POST MIXER

Corrections

28 JULY 2004

TX SSB filter response without 0 dB Buffer between RLY6 and R26/R27.

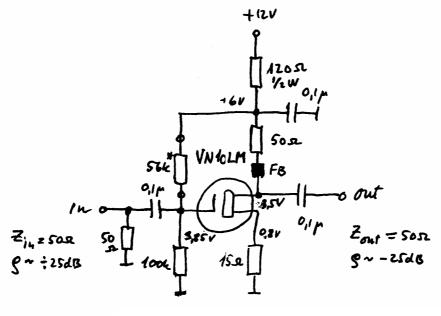
A 0 dB Buffer is placed between RLY6 and R26/R27 in order to absorb the variations in input impedance of the PIN-attenuator. With the 0 dB Buffer installed the maximum amplification in the transmitter path of the Post Mixer is approx. 28 dB. To make room for the clumsy 0 dB Buffer board C30 is transerred to where C36 used to be. RFC6 is replaced with a wire link.
